**ADDENDUM NO. 1**  
**2026 Citywide Preventative Bridge Maintenance**  
**PWE NO. BR2501**

The following changes, additions, and/or deletions are hereby made a part of the **2026 Citywide Preventative Bridge Maintenance Project**, dated March 23, 2026, as fully and completely as if the same were entirely set forth in the Plans, Specifications, and Contract documents. Changes and additions are noted in *highlighted italics*, and deletions are noted in ~~strike through~~. **The Bid opening date of April 9, 2026, at 1:30 p.m. remains unchanged.**

<b>CITYWIDE PREVENTATIVE BRIDGE MAINTENANCE</b> FEDERAL-AID NO. BHM-9936(007)	
<b>THREE MILE ROAD LAYOUT</b> <b>(TAUSICK WAY)</b>	
CITY OF WALLA WALLA	WASHINGTON
PROJECT NO. <b>BR-2501</b>	SHEET NO. <b>08</b> OF <b>34</b>
<b>B05</b>

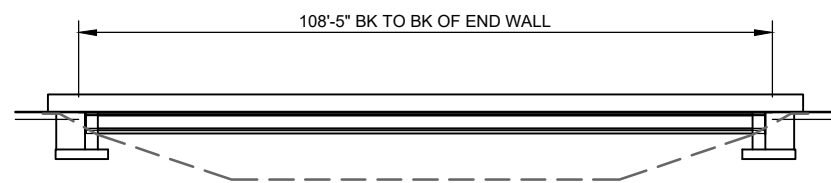
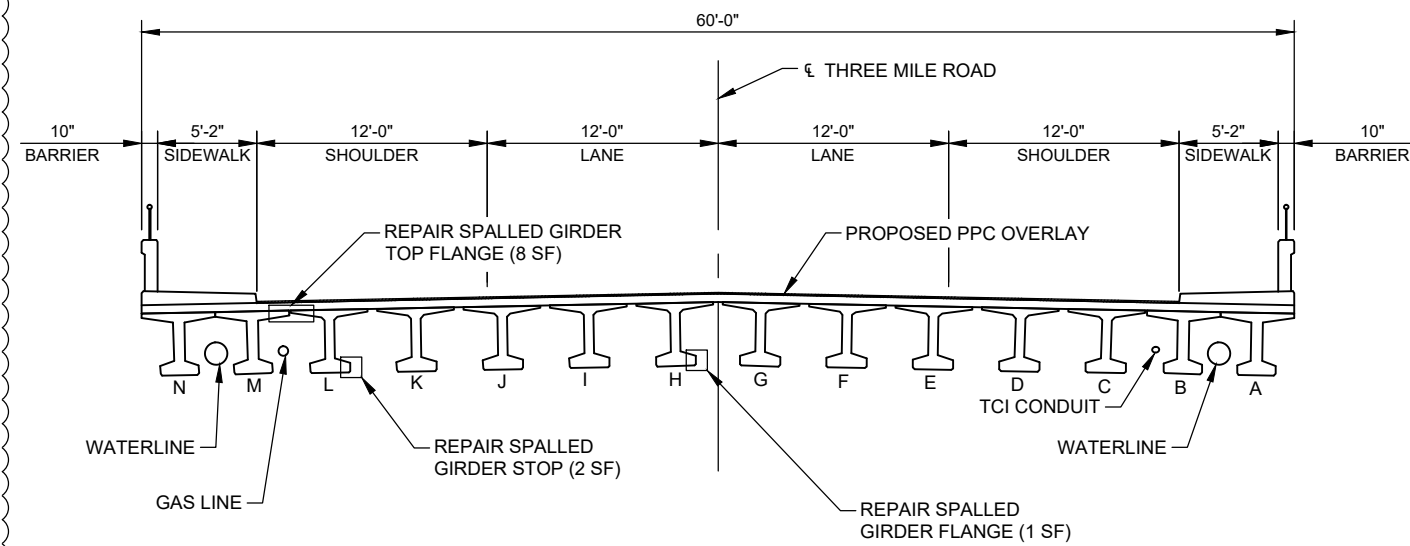
*Plan Sheet B05 – Three Mile Road Layout (Tausick Way)*

*Plan View*

The Plan View has been modified in the following ways:

*Removals*

*65 lf of Conduit Pipe 2 In. Diam.*

*169 lf of Plastic Wide Line*

*140 sf of Plastic Crosswalk Line*

*1 Plastic Bicycle Lane Symbol*

*2 Cement Conc. Curb Ramp Type – Parallel*

*2 HMA path approaches to cement conc. curb ramps*

*2 Water Valve Boxes*

*1 Manhole Frame and Lid*

*Modification:*

*HMA Transitions have been reduced from 30 lf to 5 lf as measured along the centerline of the roadway*

*Plastic Line has been reduced*
